UNITED STATES PATENT AND TRADEMARK OFFICE

| APPLICATION NO. | FILING DATE | FIRST NAMED INVENTOR | ATTORNEY DOCKET NO. | CONFIRMATION NO. |
|-----------------|-------------|----------------------|---------------------|------------------|
| 10/082,833 | 02/25/2002 | Stephen M. Graves | P00079US2A | 4638 |

| Office Action Summary | Application No. 10/082,833 | Applicant(s) GRAVES ET AL. | |

DETAILED ACTION

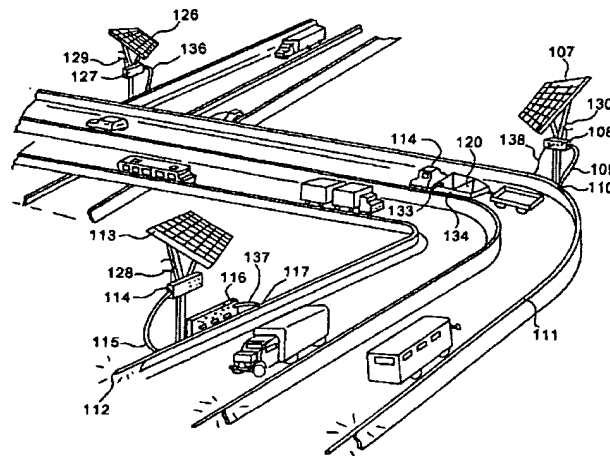
Claim 15-19, 22-24, 27-38, 41 are rejected under 35 U.S.C. 102(e) as being anticipated by Tribelsky et al (US 6,592,245 B1).

Tribelsky discloses an optical system with all the limitations set forth in the claim, including: a delineation marker (delineating the edges of the road- see figure above); wherein the delineation marker includes a guard rail for the road (figure above); wherein the guard rail extends along a curved portion of the road (figure above); wherein the delineation maker includes plurality of guard rails that are plurality of barrier walls (on either side of the road- see figure above); one or more optical transmission tubes provided on one or more of the barrier walls, the transmission tubes configured to illuminate and outline the travel path (Figure above; abstract); wherein the optical transmission tube assembly is connected to the top edge of the delineation marker (figure above); wherein the delineation marker convey impending curve or edge of the road (figure above); wherein the illumination enhances vehicle driver preview distance (inherently disclosed by the teaching of the reference).
